Town of Ramapo
Building, Planning and Zoning Department

COMMUNITY DESIGN REVIEW COMMITTEE

June 04, 2025, Revised July 7, 2025

2024.008: 1551 Route 202 Site Development Permit
1551 Route 202, Pomona
Tax Lot 33.05-2-9
Zoning: CC zoning district

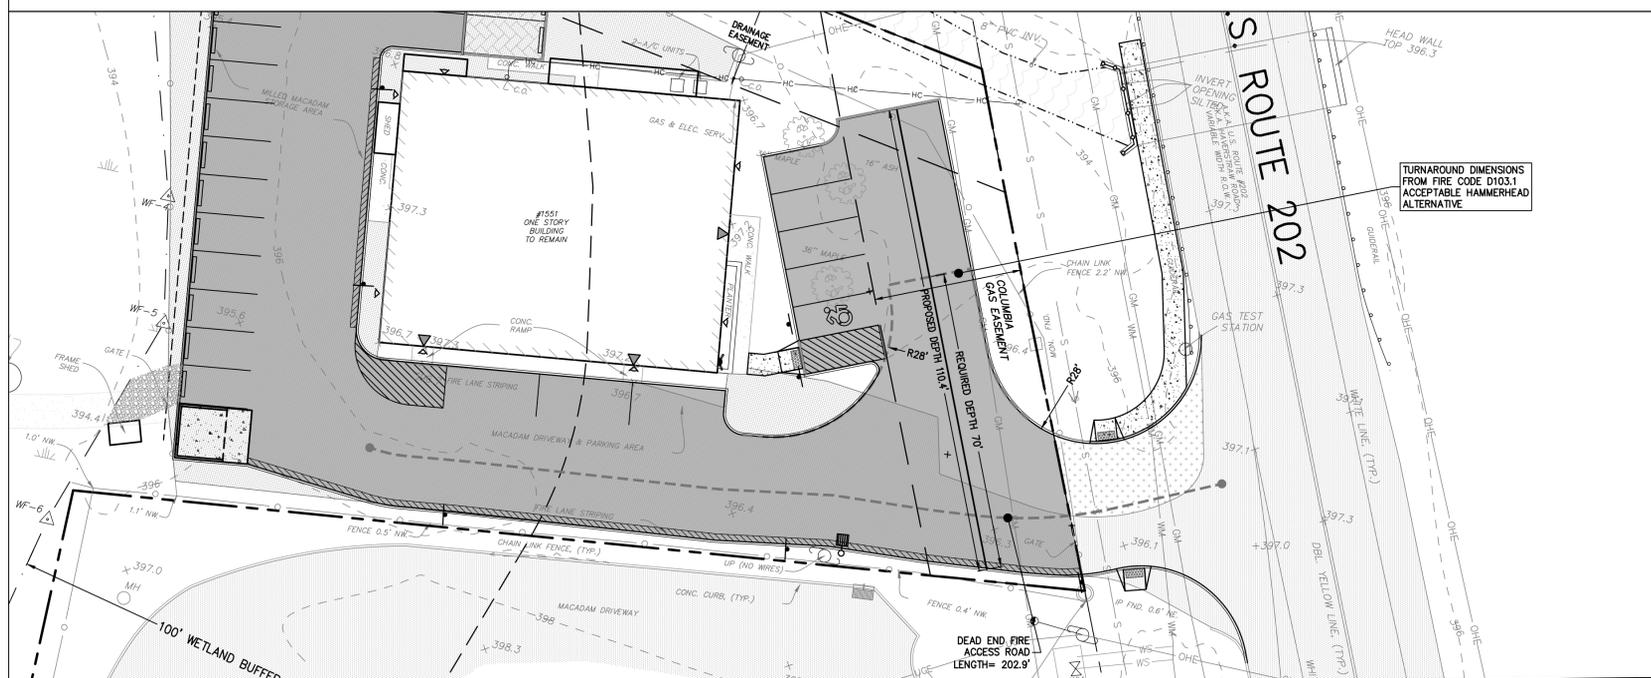
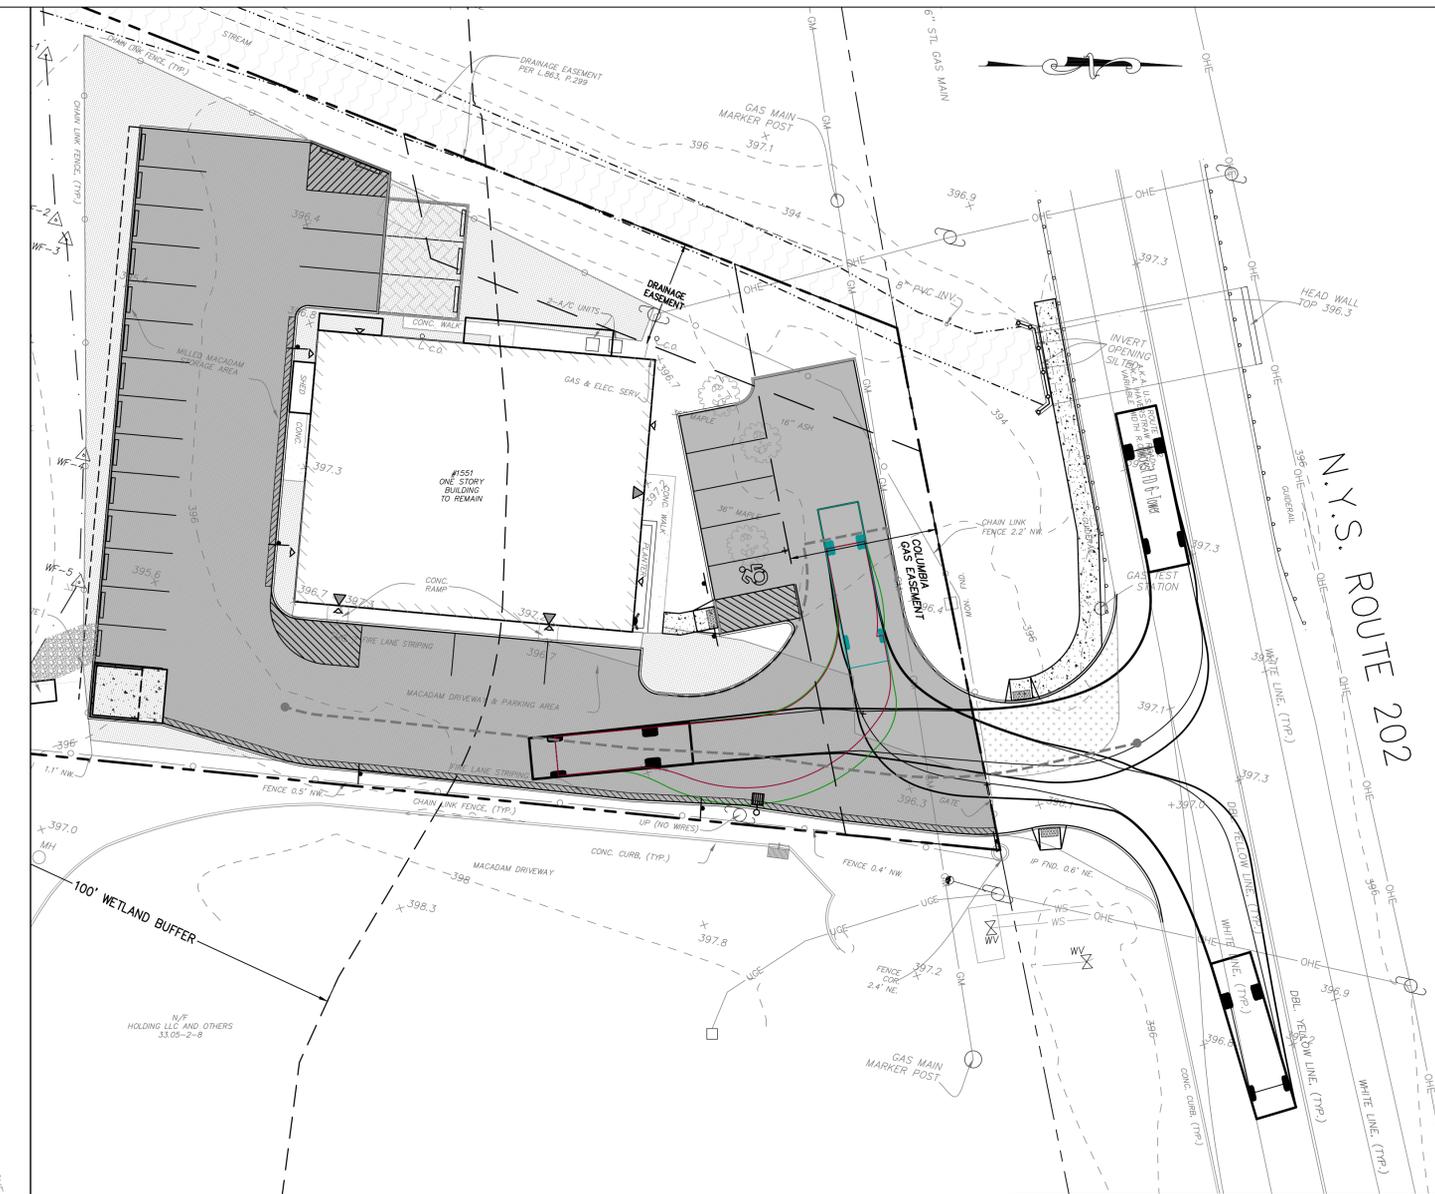
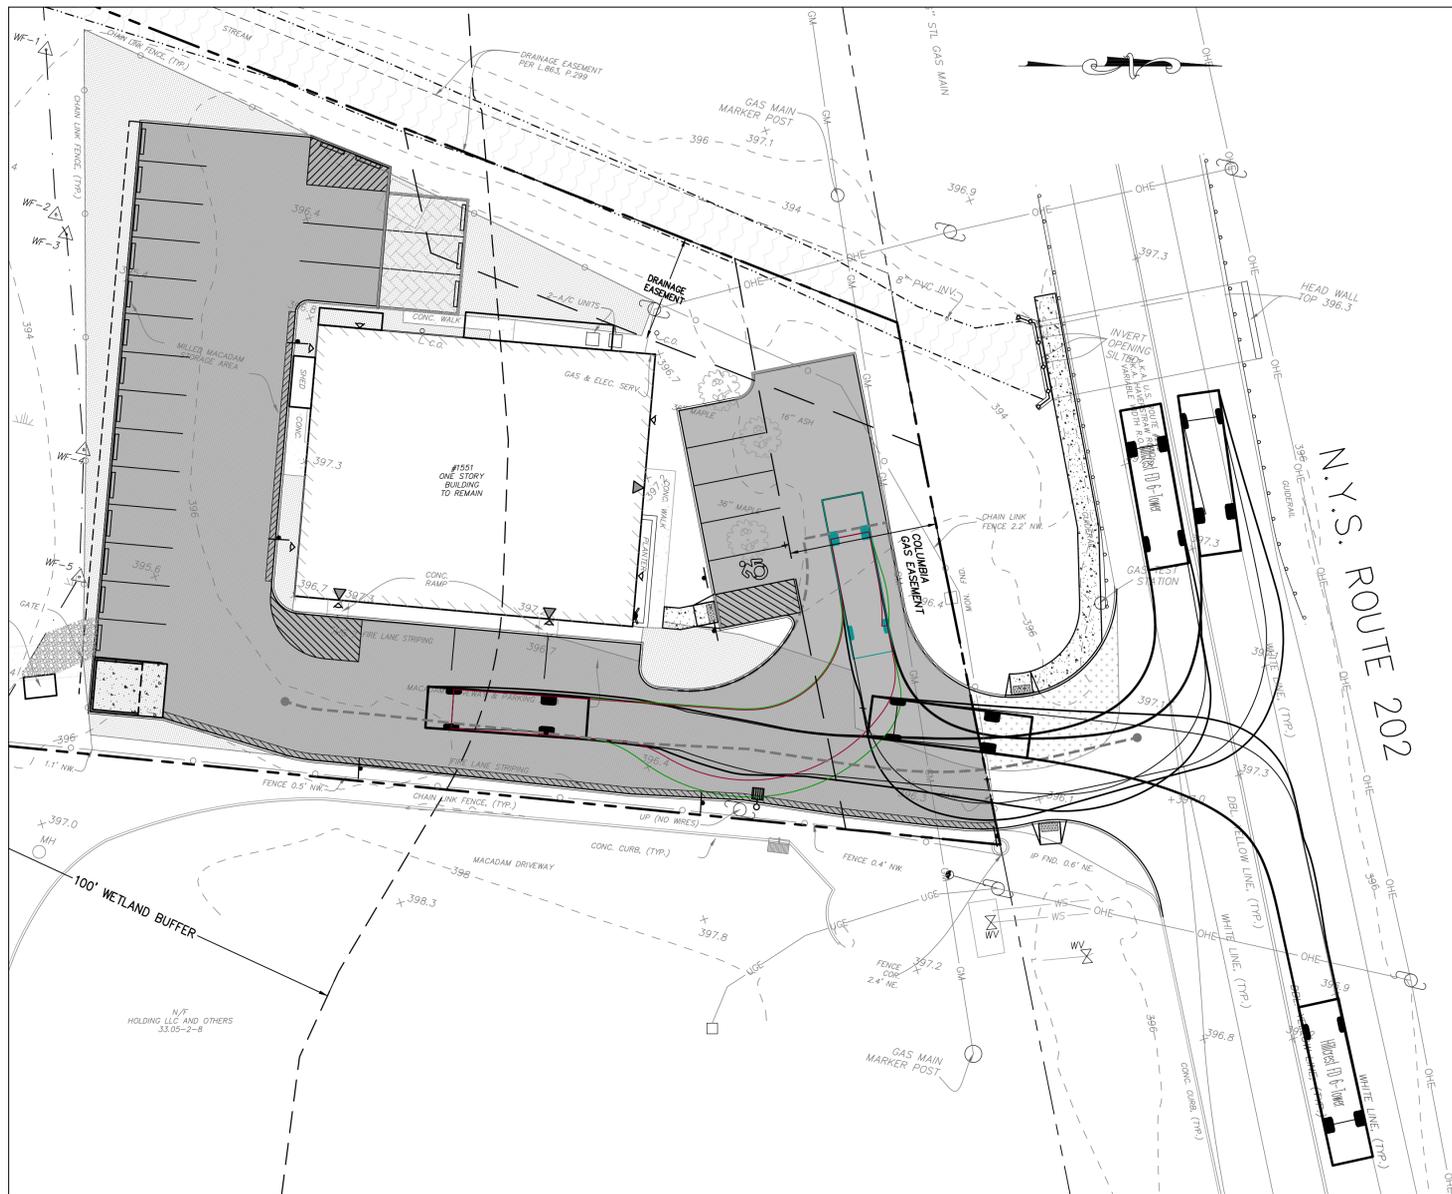
37. *COMMENT: Show and additional turning movement with the vehicle arriving from the east on NYS Route 202.*

Response: The requested turning movement has been added as requested.

- 1) The front parking aisle features a fire truck turnaround configuration that complies with the "Acceptable Alternative TO 120' hammerhead from fire code figure D103.1
- 2) The net lot area review on the layout plan was expanded.
